MONTGOMERY COUNTY HISTORIC PRESERVATION COMMISSION
STAFF REPORT

Address:	10201 Menlo Ave.	Meeting Date:	1/10/18
Resource:	Contributing Resource Capitol View Historic District	Report Date:	1/3/18
Review:	HAWP	Public Notice:	12/28/17
Case Number:	37/07-17G (continued)	Tax Credit:	None
Applicant:	Minter Farnsworth	Staff:	Dan Bruechert
Proposal:	New Construction

Staff recommends that the HPC **approve with two (2) conditions** the HAWP application.

SITE PLAN
1" = 20'

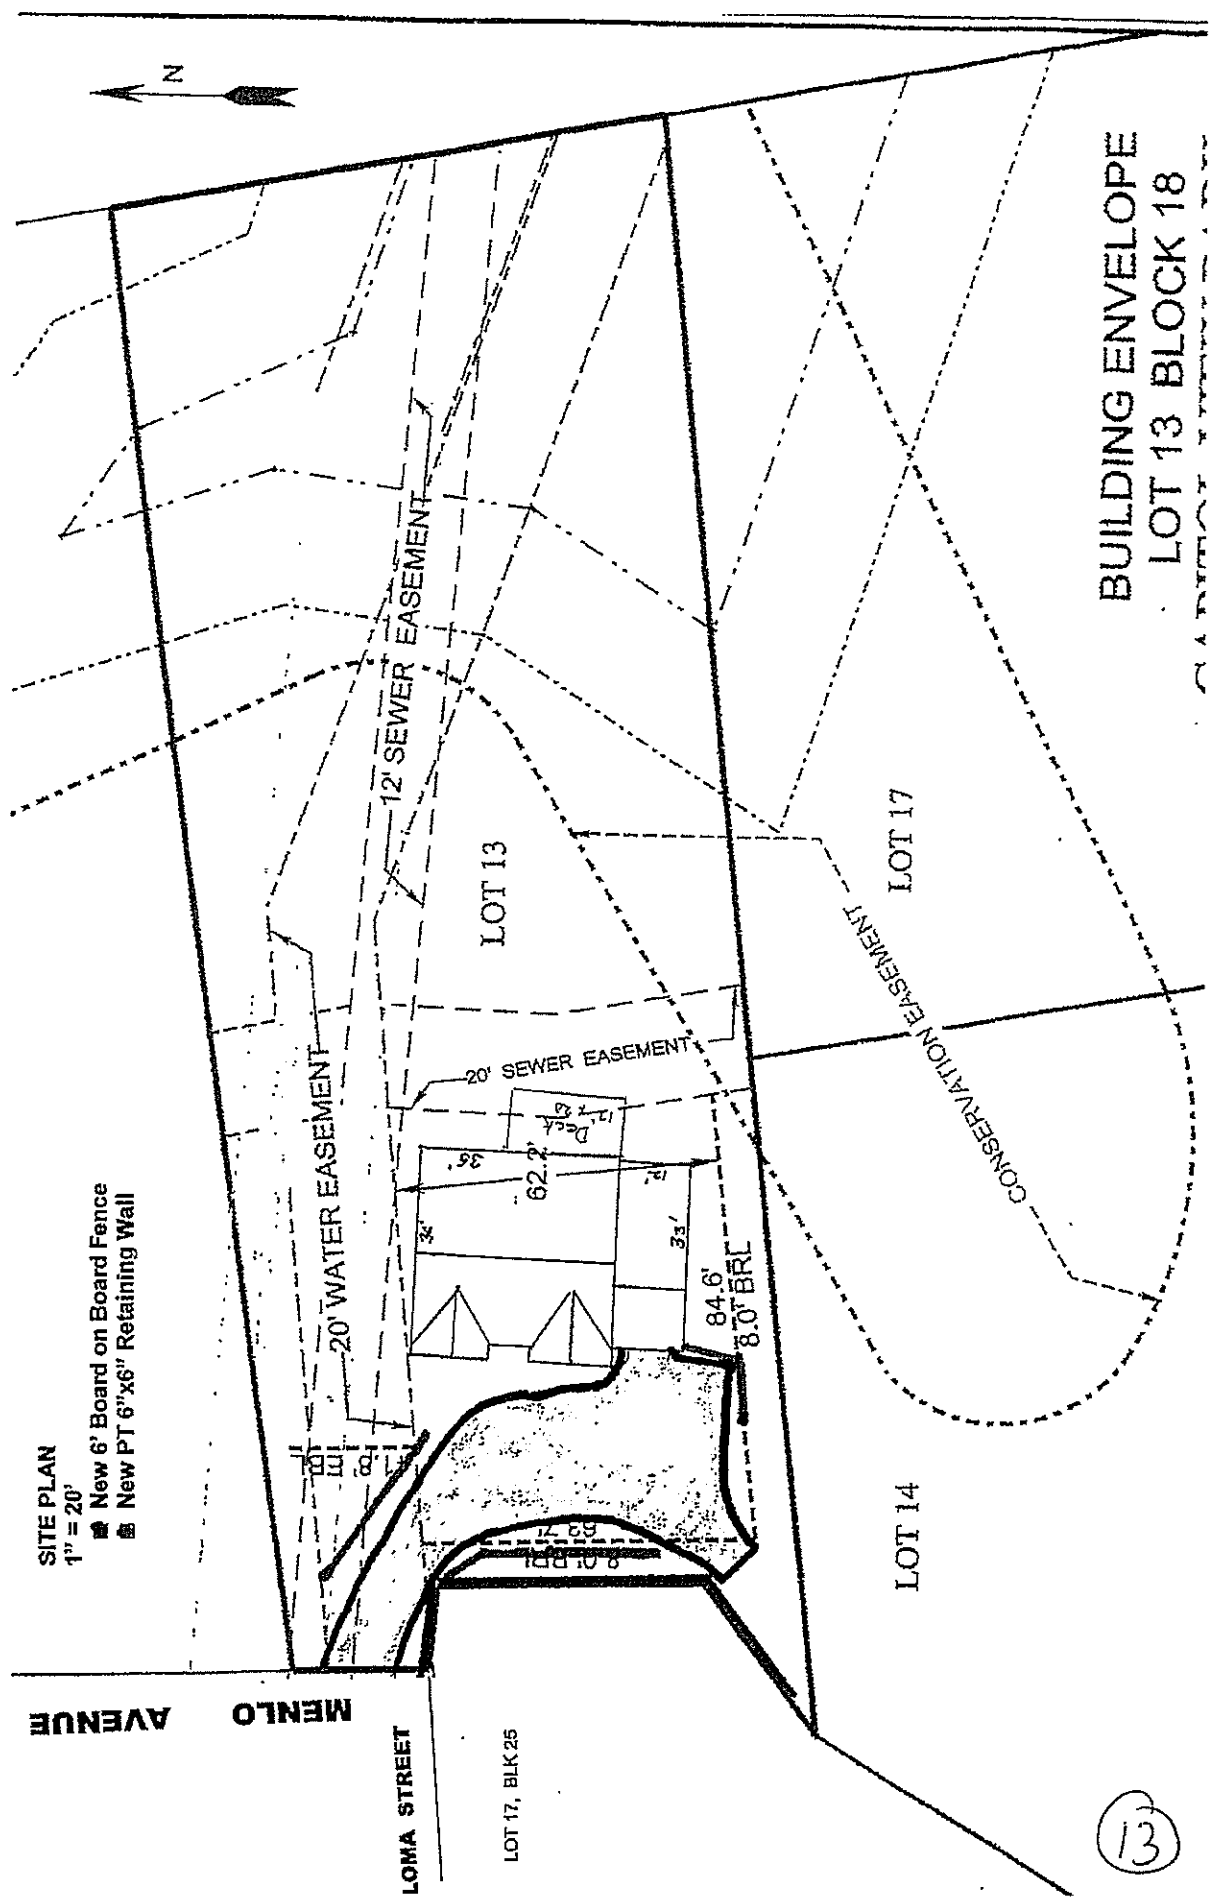
The applicant is proposing to construct a driveway and parking area to the front of the house using asphalt. This material is widely used throughout the district and will have a minimal impact on the site and the surrounding district. As the parking area will not be visible from the public right-of-way, it will not impact the district and should be approved.

The applicant is proposing to install a six foot (6') tall, wood, board on board privacy fence placed at the front boundary of the property. The HPC does not typically approve fences taller than forty-eight inches (48") in front of the rear wall plan within historic districts. The neighboring property has a fence that is approximately five feet (5') tall, which would intersect the proposed fence at the middle. The southern half of the proposed fence will be obscured by the neighbors existing fence and will not be visible. The northern portion of the fence will be visible from the public right of way and staff believes that due to the unique siting of the lot, a solid board on board design is acceptable, however, the fence height should be reduced to 48" (forty-eight inches) to the north of the neighbor's wooden fence. The fence plan is shown below.

FRONT ELEVATION 1/4" = 1'

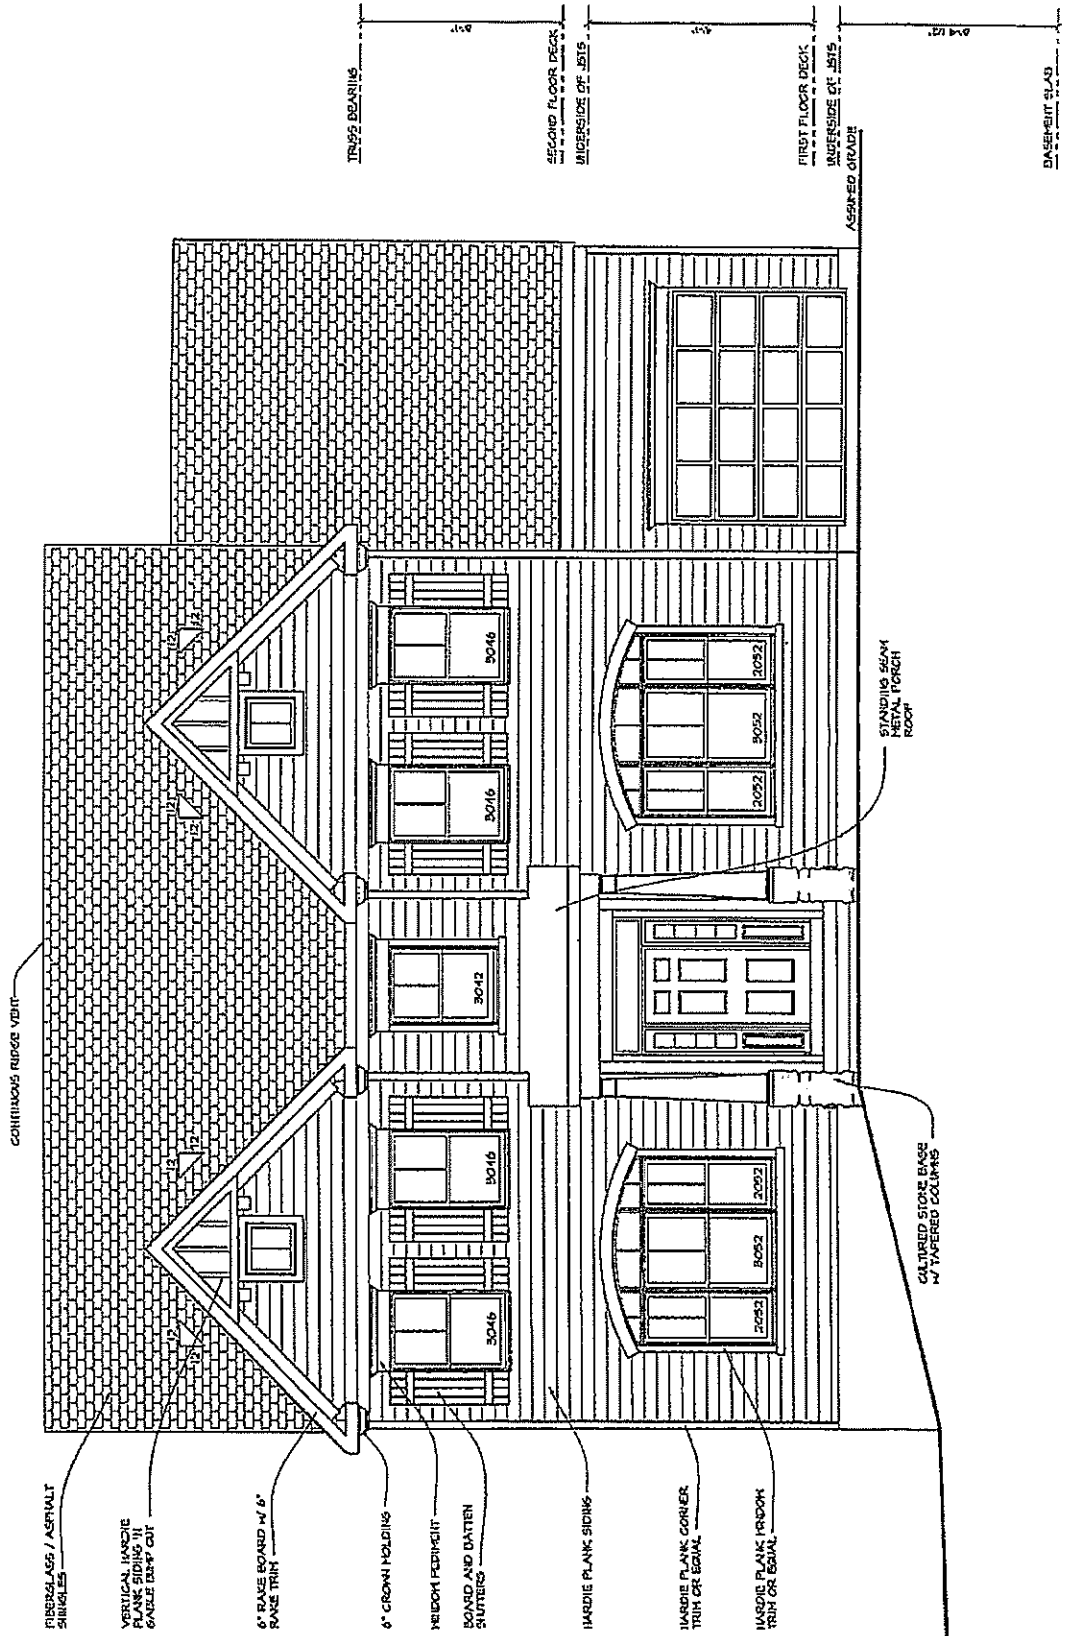
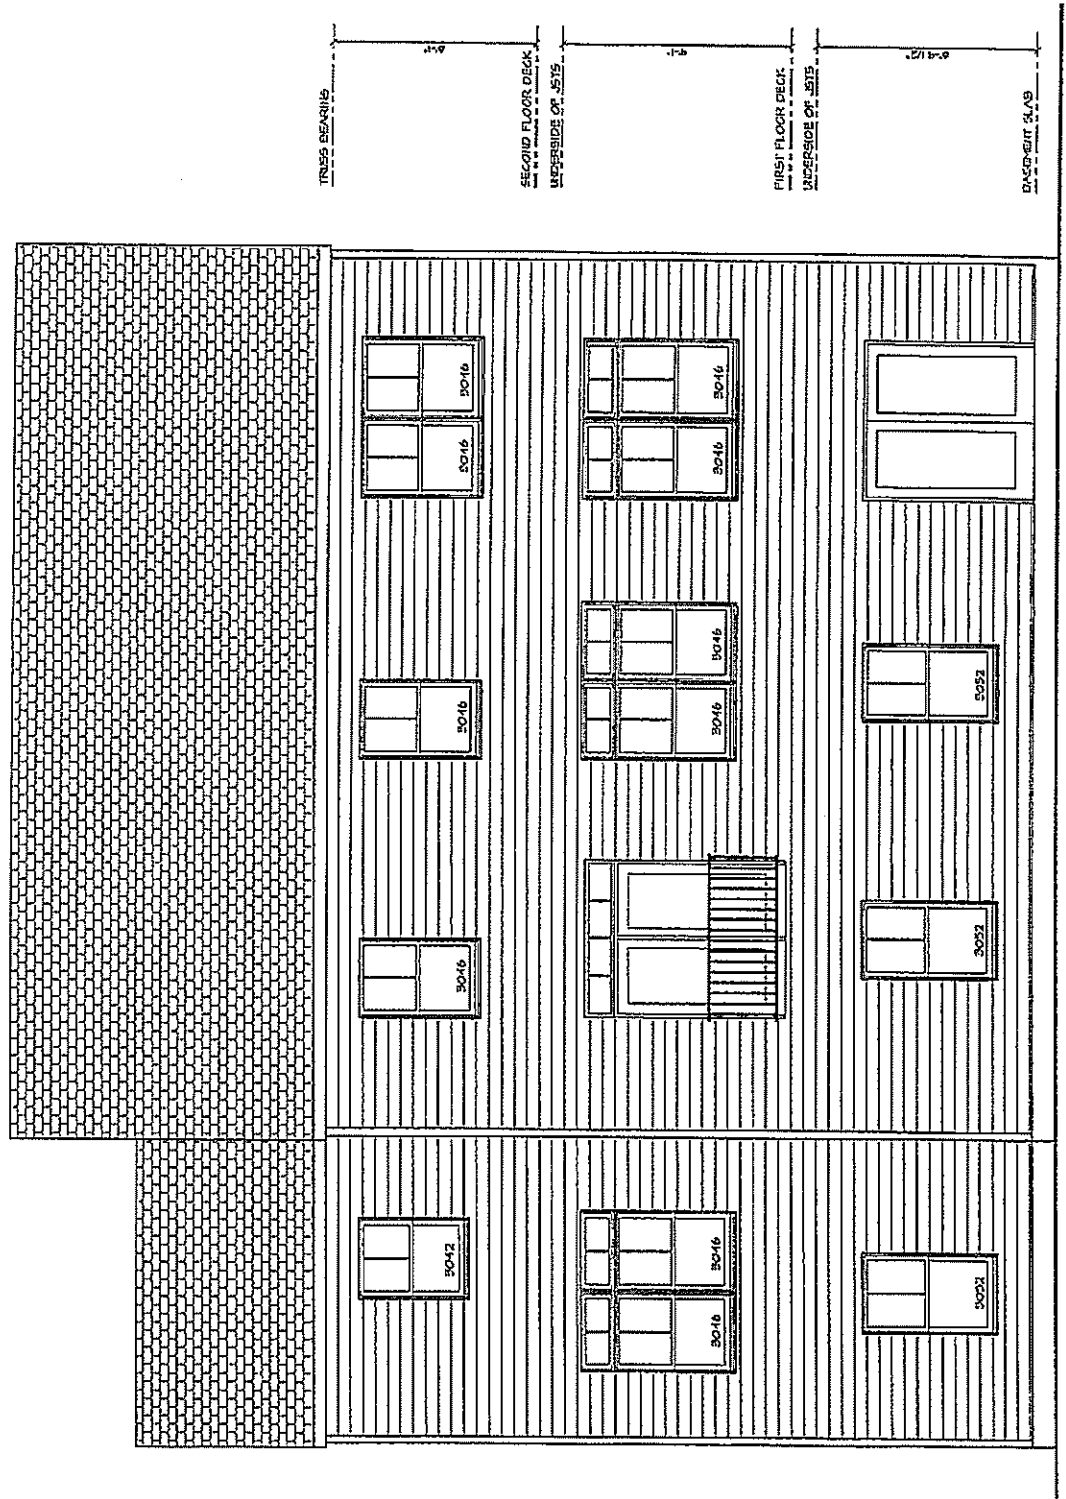
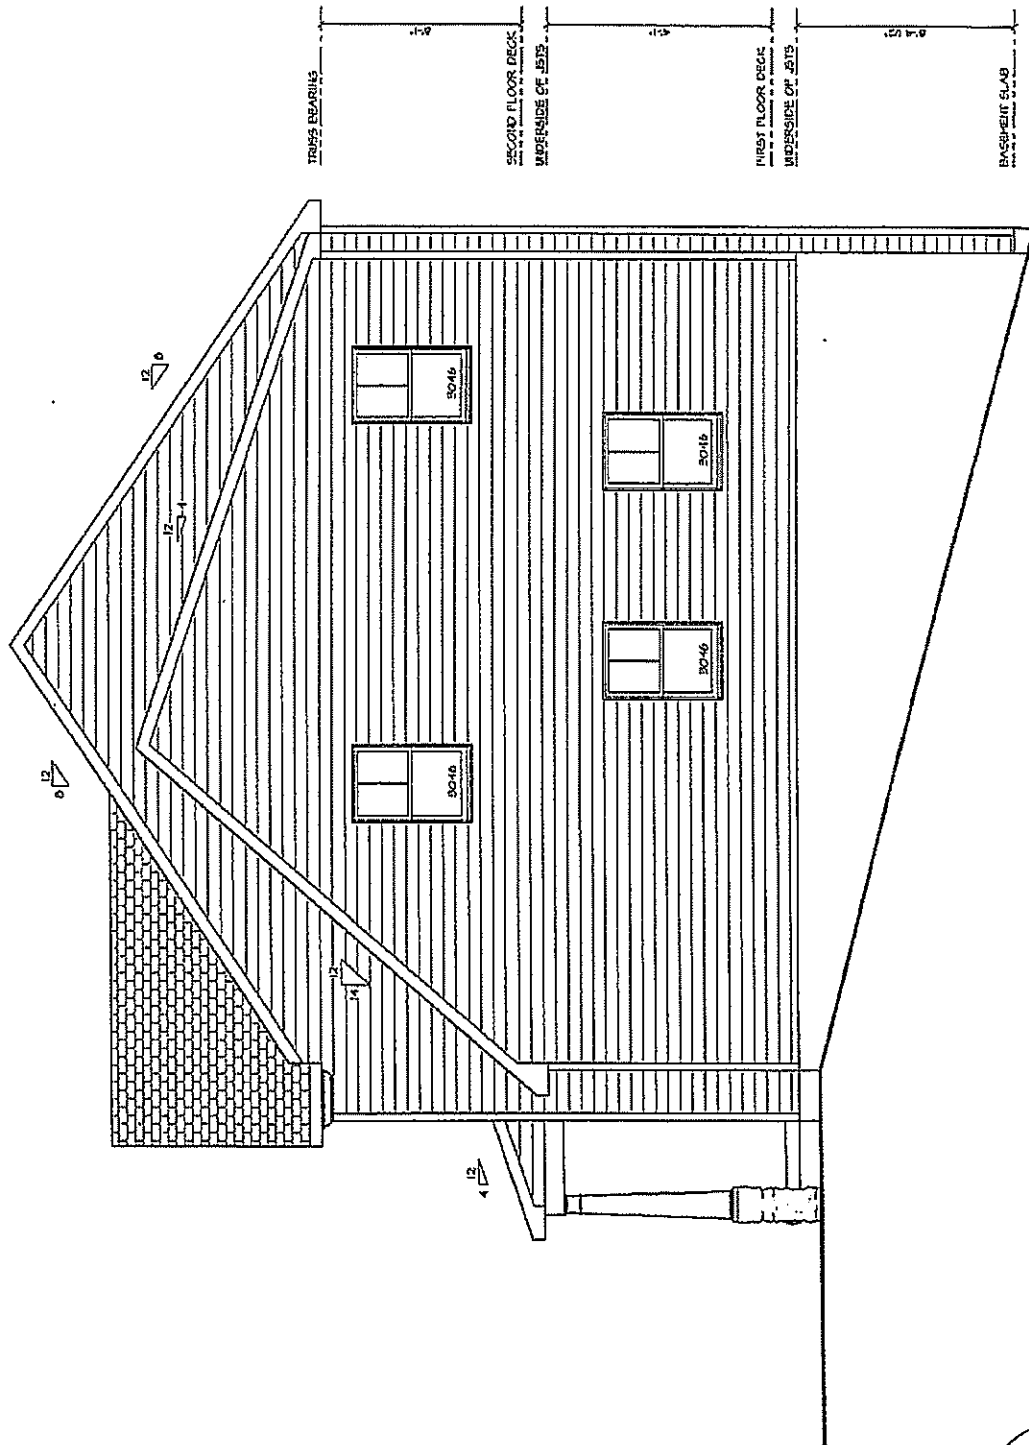
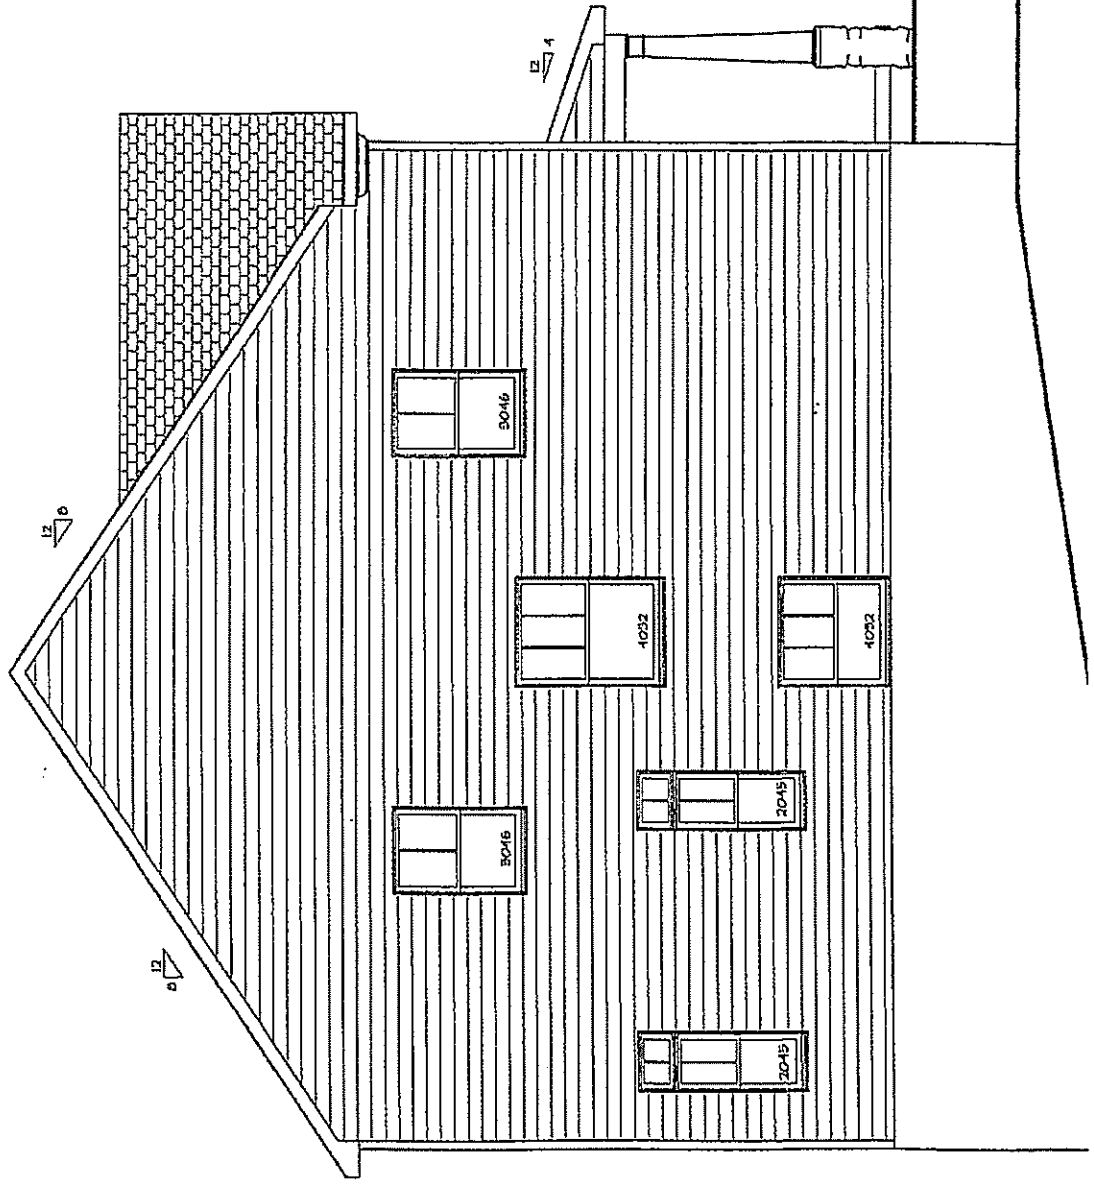
The applicant proposes to construct a new two-story, side gable house, three bays wide, with Hardi siding on the lot. The house has two smaller front facing gables and a small covered front porch. To the right there is a single bay attached garage covered in a side gable roof. Flanking the central front door, the first floor has two large bay windows covered in a metal seam roof.

The style of the house is best described as "Traditional" as it draws from several different periods of construction. While the form of the house remains unchanged from the previous submission, several decorative elements were changed in response to a Commissioner's desire to see a more Victorian house. In a desire to make the house appear more Victorian, the applicant modified the design by introducing bay windows, gable embellishments, and a decorative 2nd floor central sash windows in this scheme. In a windshield survey of the district Staff found that this house design is a slightly larger scheme from several houses constructed on Leafy Ave. (see figure 1). These houses were all reviewed and approved by the HPC in 1994. These houses all are side gable roofs with a front gables and small front porches. The Leafy Ave. were all constructed on undeveloped land and created a streetscape where none had existed before.

The applicant did not provide windows specifications with the application materials. Staff feels that the proposed one-over-one configuration is acceptable, and recommends the HPC condition approval on the applicant using a wood or clad windows.

Staff believes that the applicant's use of a rectangular house shape with a simple side gable roof form achieves a house that, where visible from the district, creates a house that will successfully blend in to the surrounding district and Staff supports its approval.

1. The proposed windows must be either wood or clad. Details need to be submitted to Staff for review and approval with final approval authority delegated to staff.
2. Placement and species of the new trees needs to be submitted with permit drawings for review and approval with final approval authority delegated to Staff.
